Item Name: Replacement Skidtube

Sequence ID/ Work Center ID	Operation Description	Set Up/ Run Hours	Tool ID	Tool #	Plan Code	Accept Qty	Reject Qty	Reject Number	Insp. Stamp
Draw Nbr	Revision Nbr								
D2580-041	(DEO) Rev.E

DRAWING NO. D2580	TITLE 205 SKIDTUBE ASSEMBLY	REV. E	DART AEROSPACE LTD ENGINEERING ORDER		D.E.O. NO. D2580-E-1	SHEET NO. SHEET 1 OF 1	SCALE NTS
DRAWN <i>JP</i>	CHECKED <i>ASS</i>	MFG. APPR. <i>EC</i>	APPROVED <i>[Signature]</i>		DE APPR. <i>[Signature]</i>		
DATE 11.12.13	DATE 11.12.13	DATE 11.12.13	DATE 11.12.13		DATE 11.12.13

CHANGE ALL C'BORED WELDED CROSSBOLT SPACERS TO SWAGED SPACERS

SECTION B-B
SCALE 5X

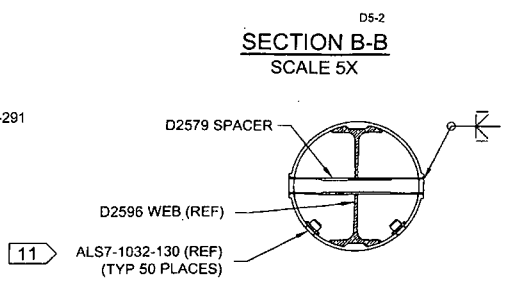
SECTION B-B, SECTION F-F, & SECTION I-I ARE AMENDED AS FOLLOWS
FOR ALL HOLES THAT WERE ORIGINALLY C'BORED:

1. INSERT D4202-1 SPACER, 20 PL (-041) OR 20 PL (-045) OR 25 PL (-047)
2. SWAGE TO Ø0.437 X 1.00 DEEP PER QSI 002
3. TRIM / GRIND FLUSH PER QSI 002

SECTION B-B, F-F, I-I
NOT TO SCALE

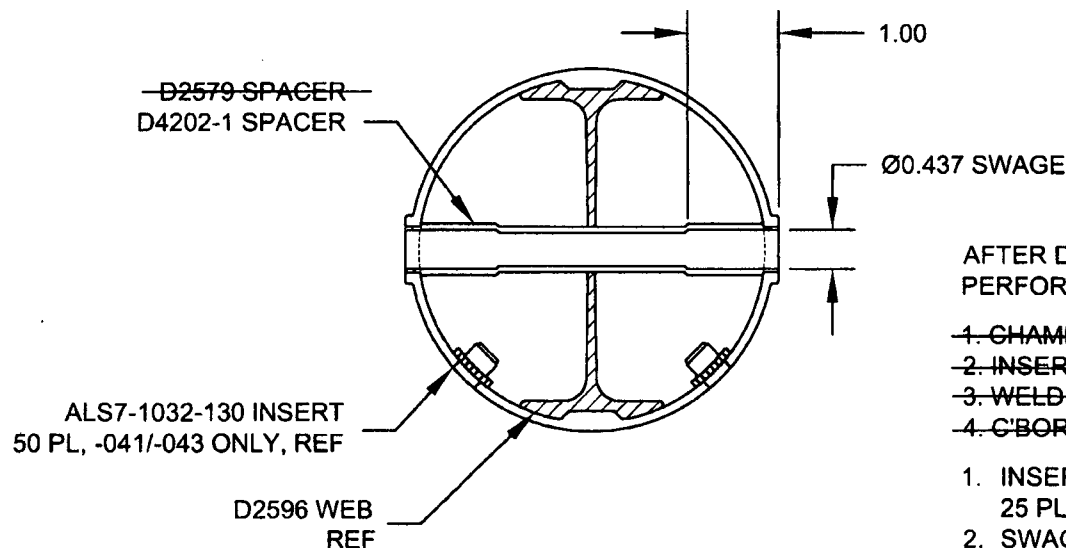
*** FOR -045 SKIDTUBE ONLY:**

WELD 4X D2579 SPACERS PER DWG
IN LOCATIONS MARKED "NO C'BORE".
REF SHEET 4 OF DWG.

- ~~1. CHAMFER HOLE 0.060 X 45°~~
- ~~2. INSERT D2579 SPACER (20 PLACES)~~
- ~~3. WELD INTO PLACE AND GRIND FLUSH~~
- ~~4. C'BORE D2579 SPACER TO Ø0.437 X 1.00 DEEP~~
